Re: Juan Tabo S.C
845 Juan Tabo Blvd. NE
Traffic Circulation Layout
Architect's Stamp 12-14-23 (K21-D019A)

Based upon the information provided in your submittal received 12-14-23, the above referenced plan cannot be approved for Building Permit until the following comments are addressed:

TRAFFIC CIRCULATION LAYOUT

7 BICYCLE RACK
SCALE: 3/4"=1'-0"

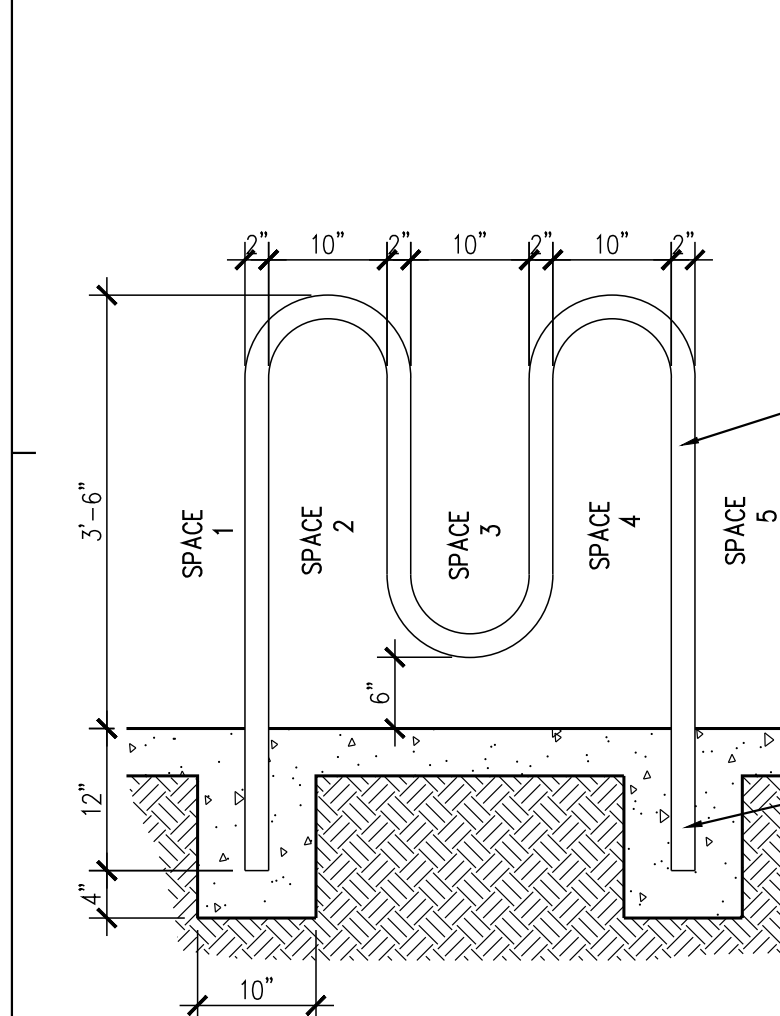
- a. The rack shall be a minimum 30 inches tall and 18 inches wide.
 - b. The bicycle frame shall be supported horizontally at two or more places. Comb/toaster racks are not allowed.

- c. The rack shall be designed to support the bicycle in an upright position. See the IDO for additional information.
 - d. The rack allows varying bicycle frame sizes and styles to be attached.

- e. The user is not required to lift the bicycle onto the bicycle rack.
 - f. Each bicycle parking space is accessible without moving another bicycle.

17. Bicycle racks shall be sturdy and anchored to a concrete pad.
18. A 1-foot clear zone around the bicycle parking stall shall be provided.
19. Bicycle parking spaces shall be at least 6 feet long and 2 feet wide.

12 SITE PLAN
SCALE: 3/16"=1'-0"

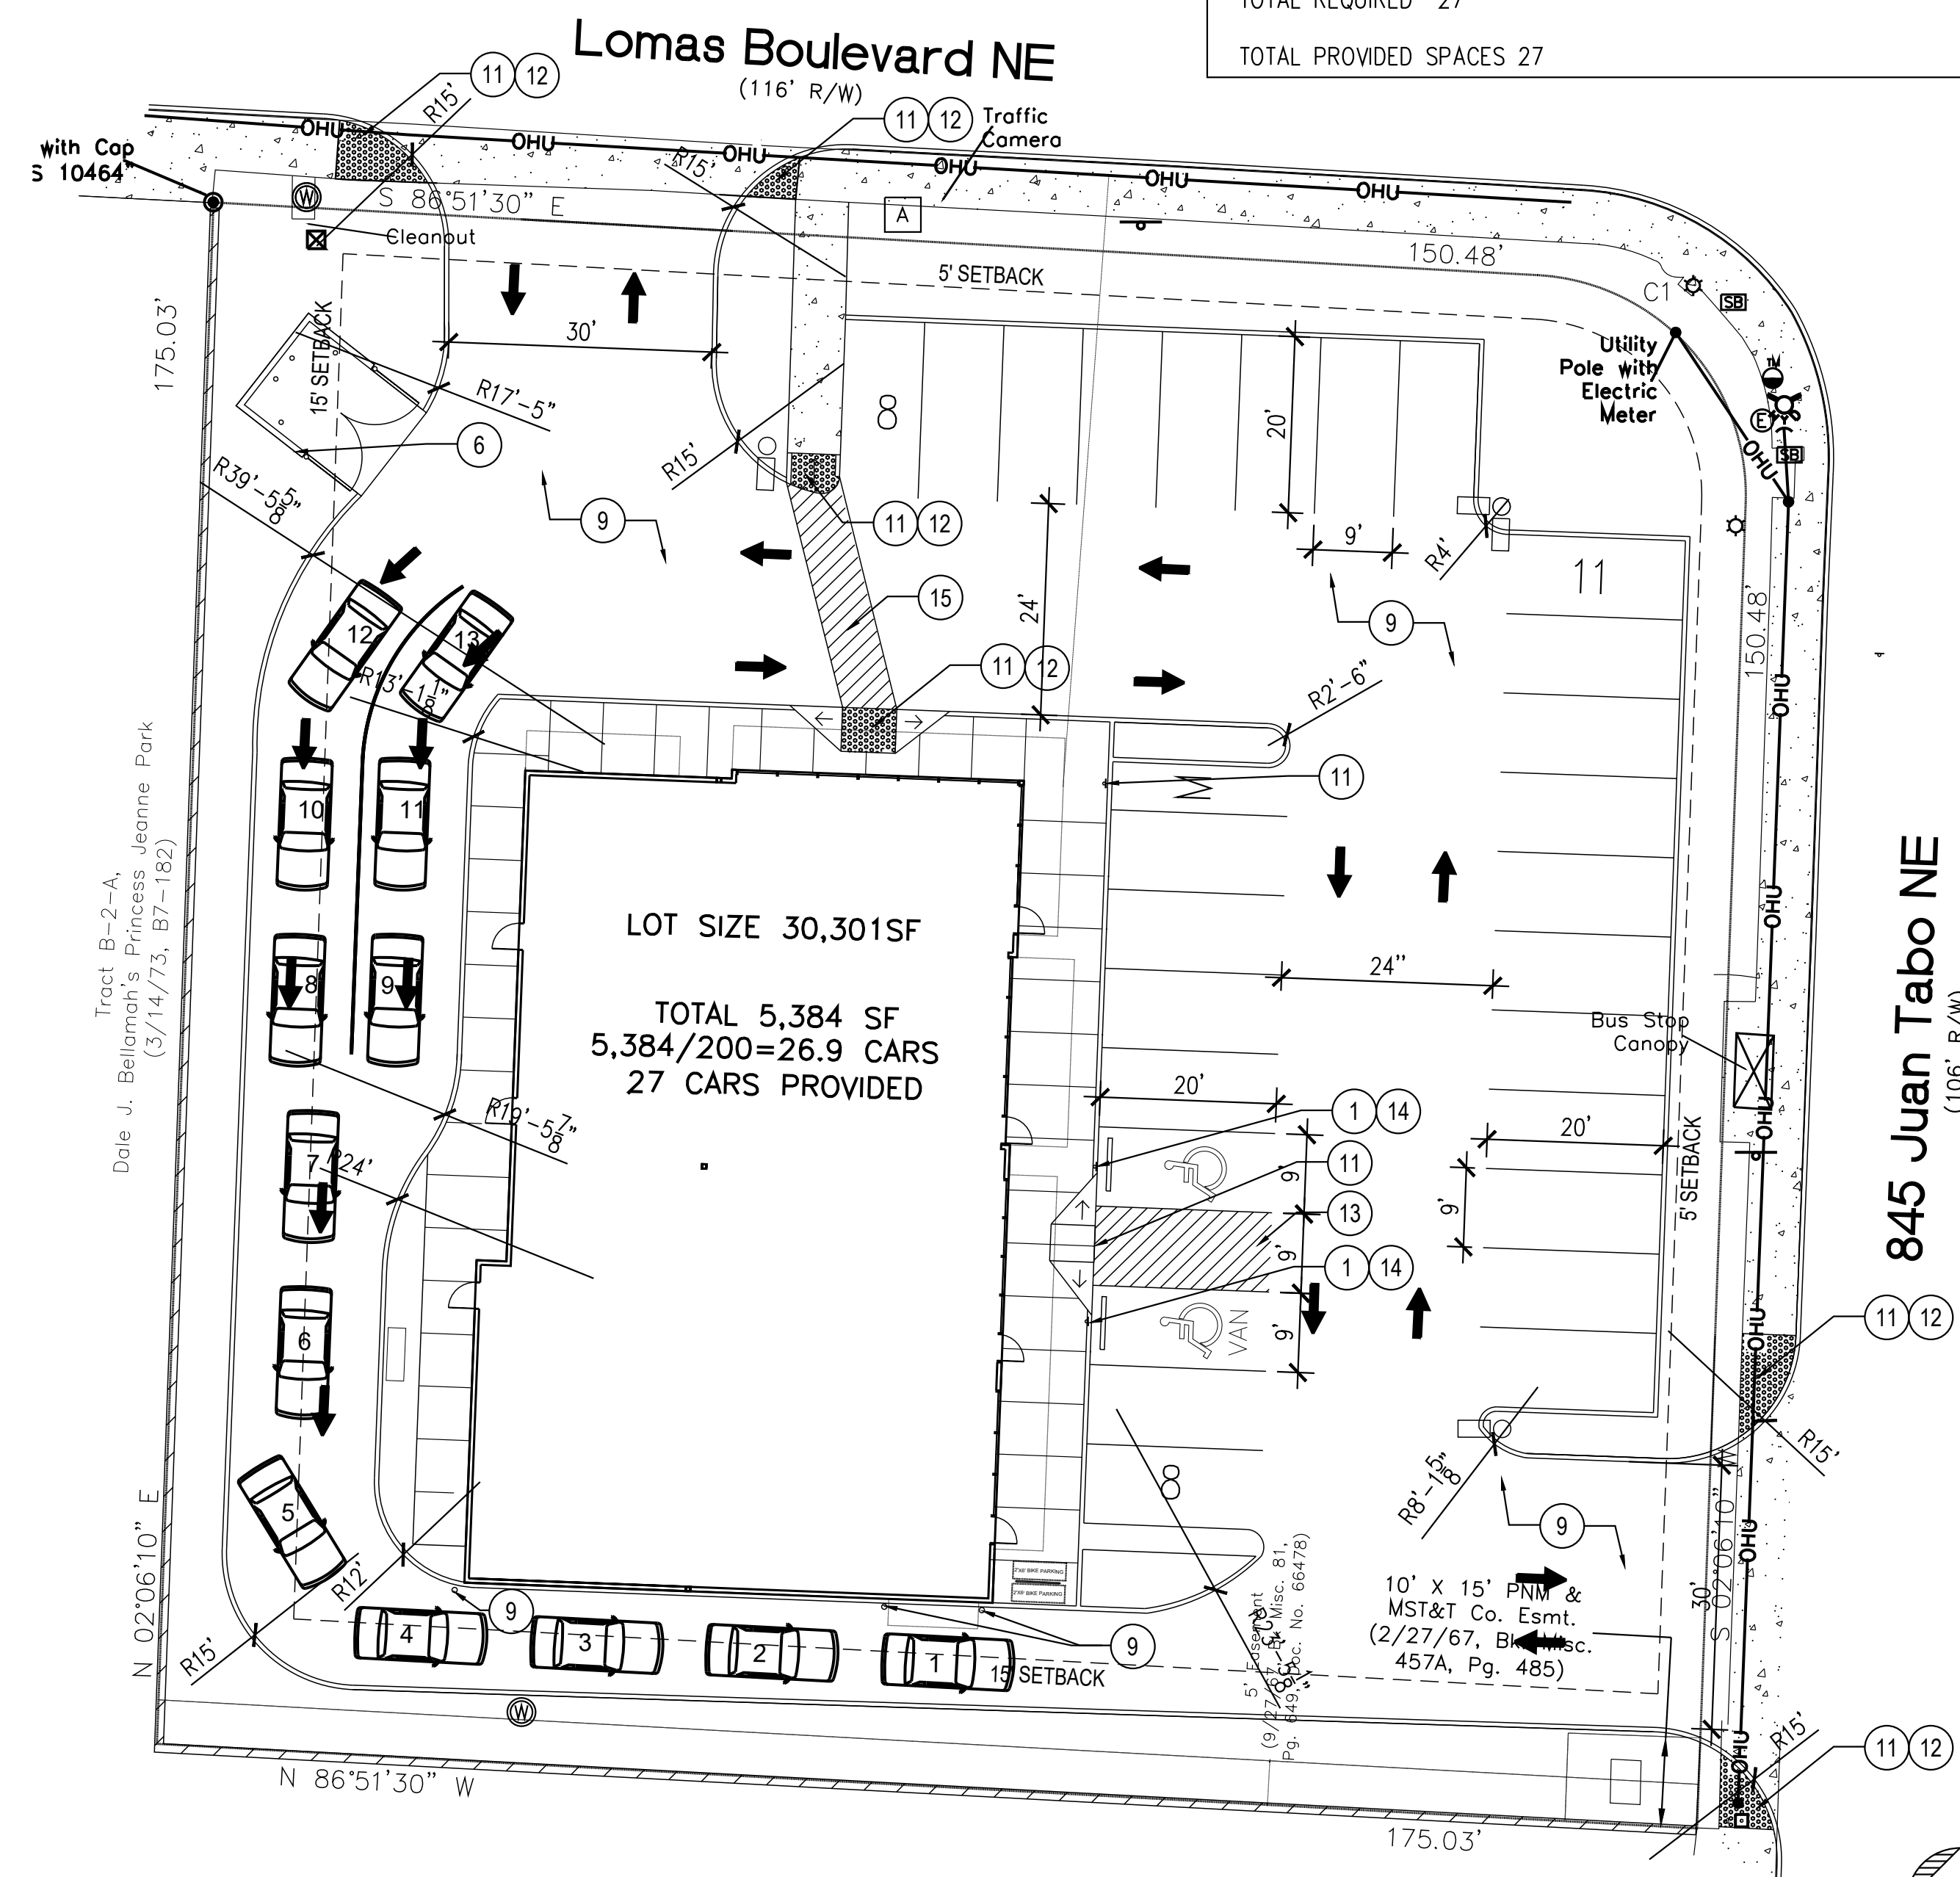
1. Please show a vicinity map showing the location of the development in relation to streets and well known landmarks.
2. List the number of Motorcycle and Bicycle parking spaces required by the IDO.
3. Identify all existing access easements and rights of way width dimensions.
4. Distance from the site access off Lomas Blvd. to intersection must be minimum 300 ft. the distance from the site access off Juan Tabo Blvd. to the intersection must be minimum 200 ft. Please show these dimensions on the site plan.
5. Please provide details for both site accesses.
6. the minimum width for the proposed ADA parking space is 8.5 ft. Please revise ADA parking spaces details.
7. The proposed ADA ramps on the site doesn't match the details for the ADA ramp.

8. Minimum ADA landing area must be 5'X 5'.

9. The ADA access aisles shall have the words **"NO PARKING"** in capital letters, each of which shall be at least one foot high and at least two inches wide, placed at the rear of the parking space so as to be close to where an adjacent vehicle's rear tire would be placed. (66-1-4.1.B NMSA 1978).

10. It is not apparent what type of pavement surface is being proposed. A hard driving surface will be required as part of this proposed project for parking area and drive aisles.

11. All one-way drives shall have "One Way" and "Do Not Enter" signage and pavement markings. Please show detail and location of posted signs and striping.

12. The minimum drive through lane width is 12 feet with a 25 foot minimum radius (inside edge) for all turns. (A 15 foot radius can be used with an increase in lane width to 14 feet). Please dimension all lane widths and radii.

13. Please revise keynotes 9 & 12 and keynote 15 is missing.
14. Motorcycle parking spaces shall be designated by its own conspicuously posted upright sign, either free-standing or wall mounted per the zoning code.

15. The pavement marking "MC" should be shown in the opposite direction for motorcycles entering the parking space.
16. All bicycle racks shall be designed according to the following guidelines:

20. Per the IDO, a 6 ft. wide ADA accessible pedestrian pathway is required from the public sidewalk to the building entrances. Please clearly show this pathway and provide details.

21. Per DPM, a 6 ft. wide ADA accessible pedestrian pathway is required from the ADA parking stall access aisles to the building entrances. Please clearly show this pathway and provide details.

22. ADA accessible pedestrian pathway should not be placed behind parking space or adjacent to a vehicular way. Vehicle and pedestrian/wheel chair conflicts should be avoided as much as possible.

23. Show the clear sight triangle and add the following note to the plan: "Landscaping and signage will not interfere with clear sight requirements. Therefore, signs, walls, trees, and shrubbery between 3 and 8 feet tall (as measured from the gutter pan) will not be acceptable in the clear sight triangle.
24. Please specify the City Standard Drawing Number when applicable.
25. Unused curb cuts must be replaced with sidewalk and curb & gutter. A build note must be provided referring to the appropriate City Standard drawing.
26. Add a note stating "All broken or cracked sidewalk must be replaced with sidewalk and curb & gutter." A build note must be provided referring to the appropriate City Standard drawing.
27. Please provide a letter of response for all comments given.
